Product Change Notification

Product Group: OPT/Tue Jun 4, 2024/PCN-OPT-1327-2024-REV-1

VBP / VBPW Series-Pre-plated LF change/ Silver paste 2nd source

VSH VBP / VBPW series PCN Summary

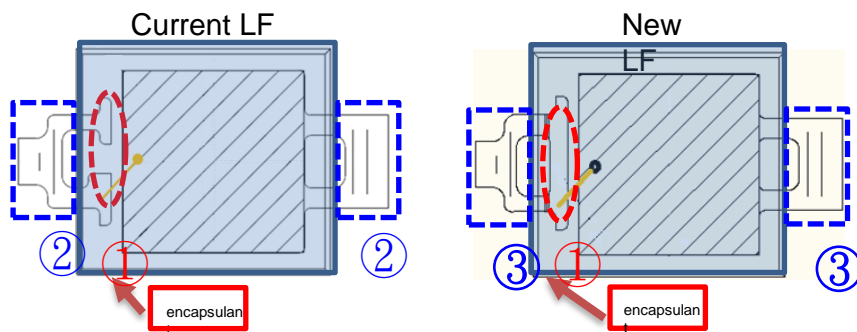
Product	Pre-plated LF (Ag)	Silver paste-2 nd
VBP104FAS VBP104FASR VBP104S VBP104SR	RA Pass	
VBPW34FAS / VBPW34FASBDD VBPW34FASR VBPW34S / VBPW34VR VBPW34SR

LF and Silver paste will be changed.
